Station Hill Reading - Planning Permission REF. 192032 (Phase 2)
Condition 33: Drainage Scheme

Compliance with the approved drainage strategy can be seen when comparing the various discharge rates across the development, reference enclosed revisions of drawing SHRN-RAM-S2-00-DR-C-0120 - NORTH SITE PHASE 2 PROPOSED SURFACE WATER DRAINAGE LAYOUT GROUND FLOOR – PODIUM:

NORTH SITE PHASE 2
PROPOSED SURFACE WATER DRAINAGE LAYOUT
GROUND FLOOR - PODIUM

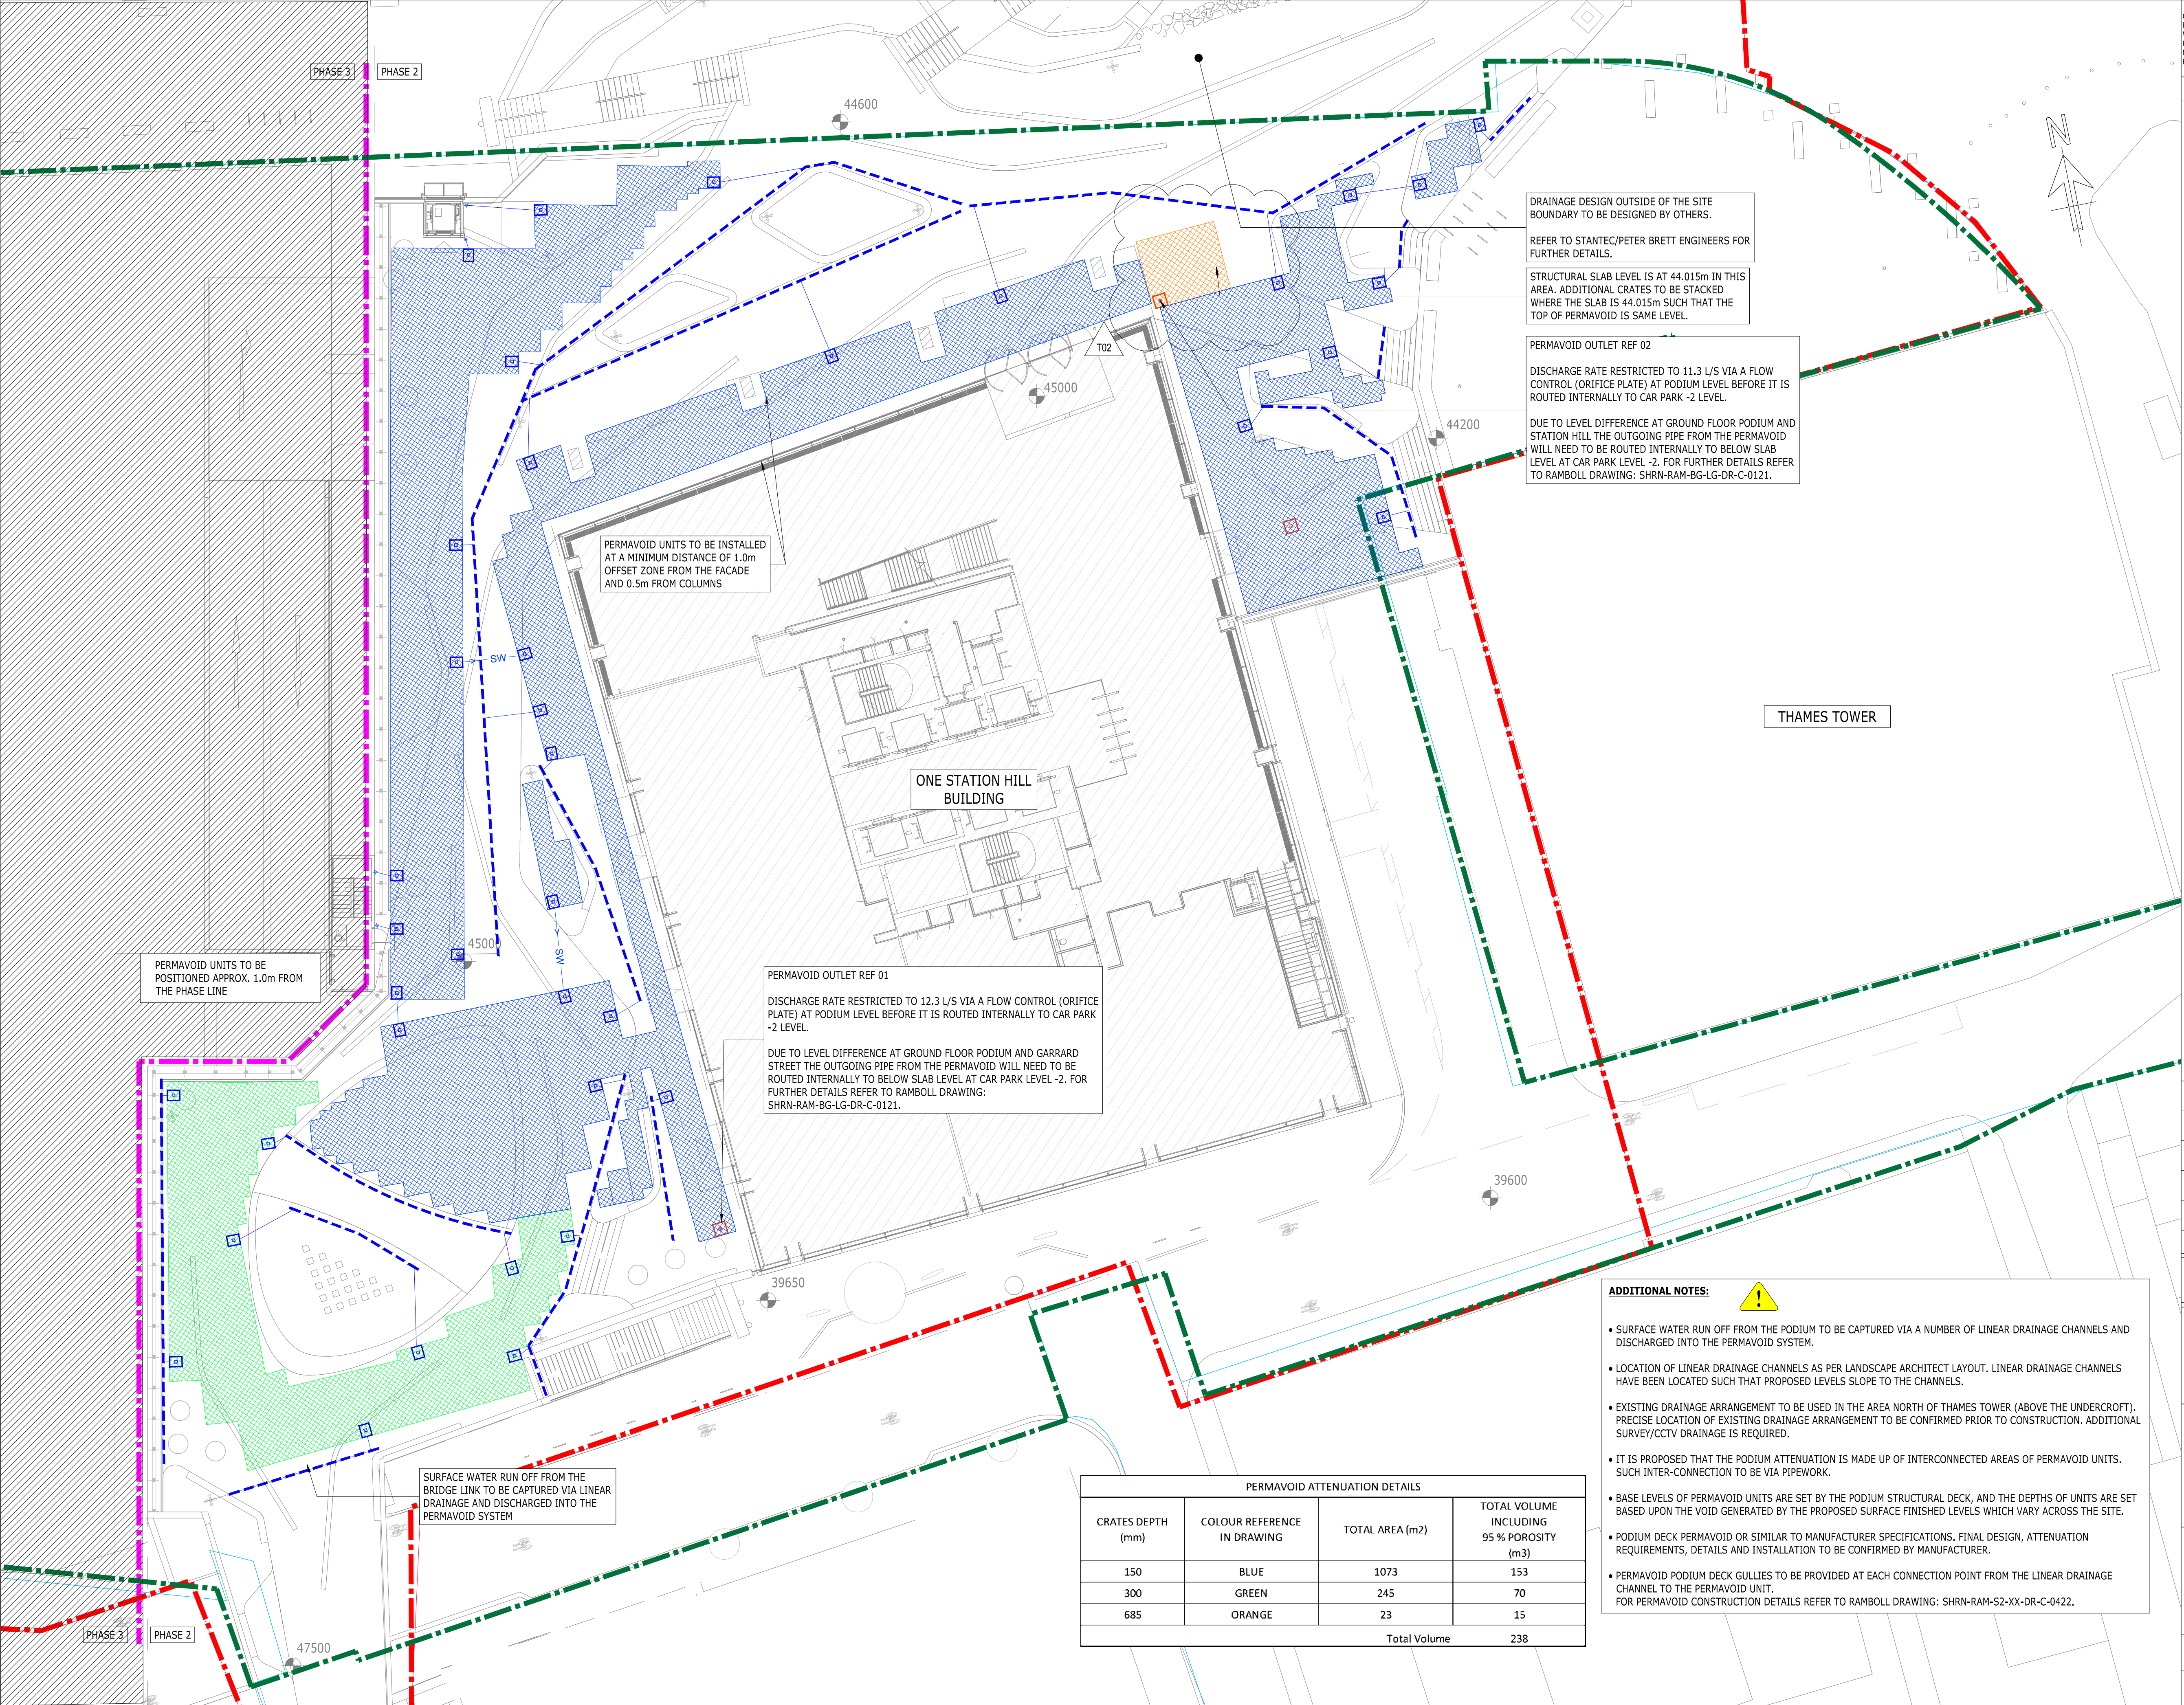
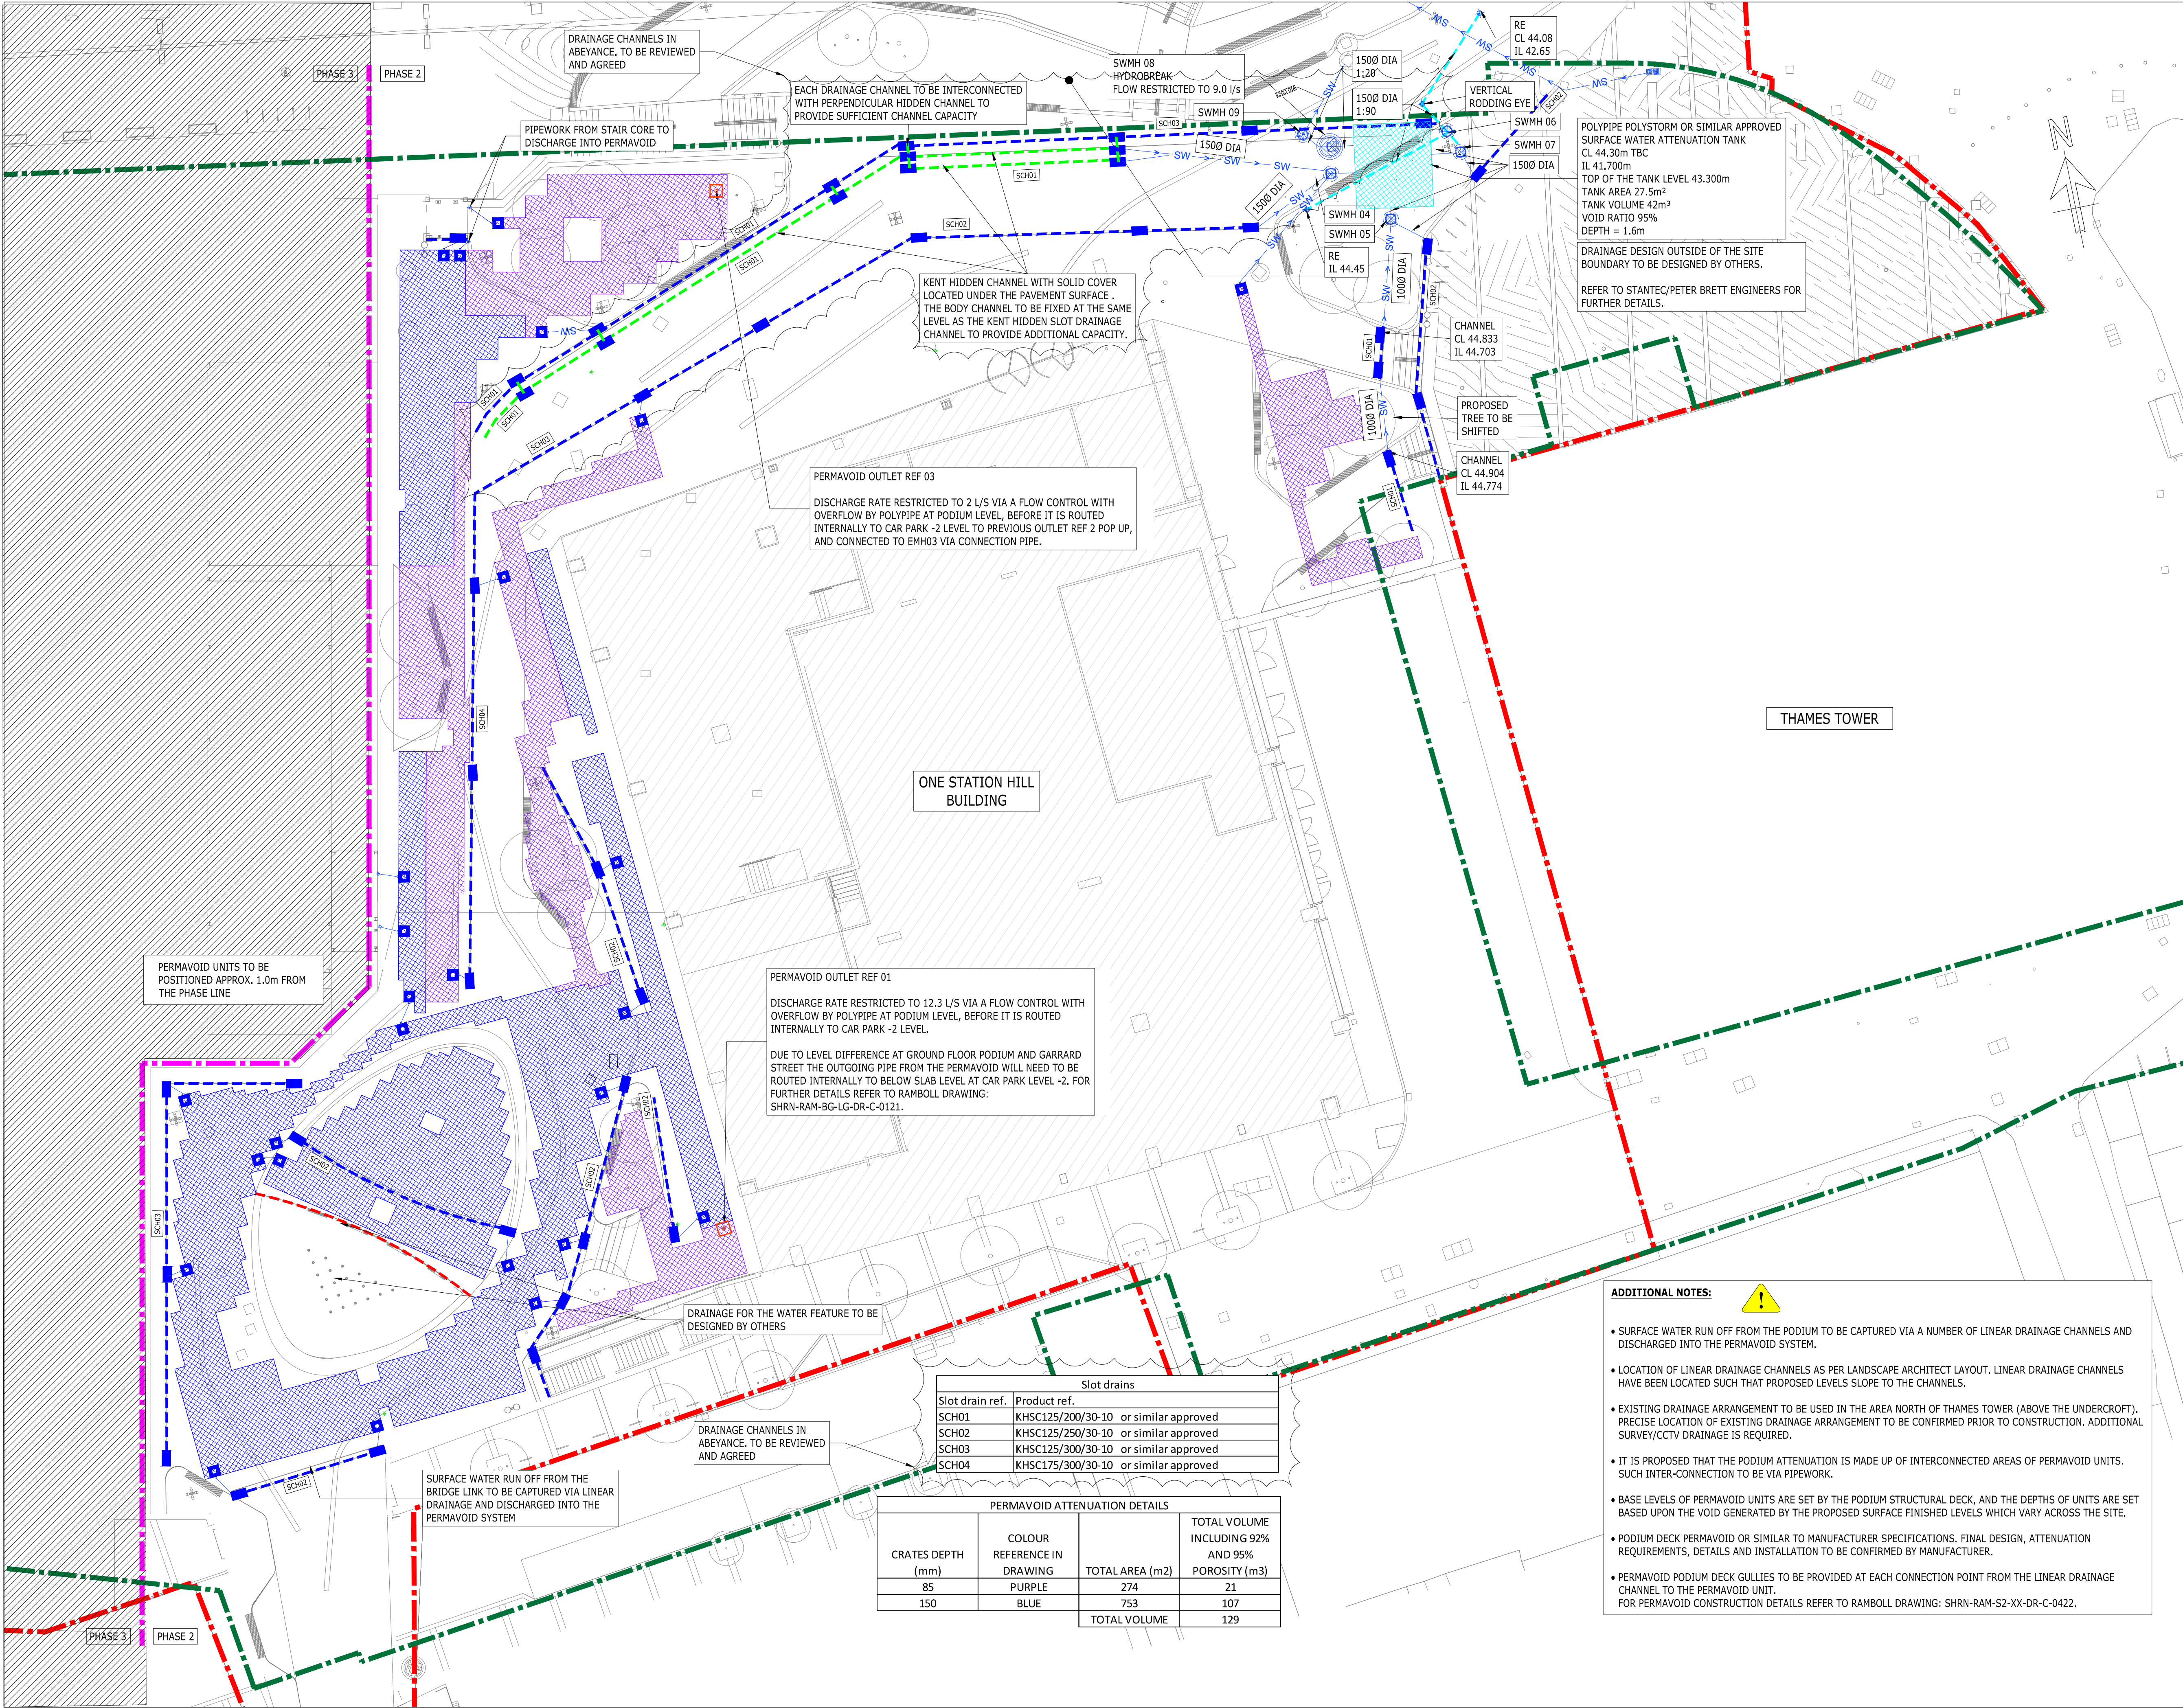
The podium arrangement has developed over time – across subsequent Non-material Amendment submissions and with the refinement of the product specific installation drawings. The result is a reduction in the plan extent of the podium attenuation due to:

- Updates to the planters and external uses changing the distribution of attenuation storage across the podium.
- Storage volume contained within cellular tanks displaced to an area within the general filling / land raise area to the northwest of the site.
- Preference to utilise channels drains and concealed pipes to convey stormwater across the podium has reduced the need for attenuation crates over and above their attenuation function.

The affect of these changes can be seen when comparing the storage volume solely within the cellular attenuation system which reveals a 28% reduction in total volume:

Drainage Strategy: Permavoid / cellular storage = 238m³

Construction issue: Permavoid / cellular storage = 171m³

Drainage Strategy – Rev T02	Construction issue – Rev C06
Garrard Street	Permavoid outlet 01 = 12.3l/s	Permavoid outlet 01 = 12.3l/s
to Station Hill	Permavoid outlet 02 = 11.3l/s	Permavoid outlet 03 = 2.0l/s
		SWMH 08 = 9.0l/s
Restriction / performance	Ref 4.1 of strategy = 23.6l/s	Sum of outlets = 23.3l/s

To conclude, whilst the arrangement of the attenuation elements has evolved over time the general philosophy, materials, final outfall locations from the site and discharge rates are unaffected and the overall performance and characteristics of the solutions remain as per the original Drainage Strategy document.
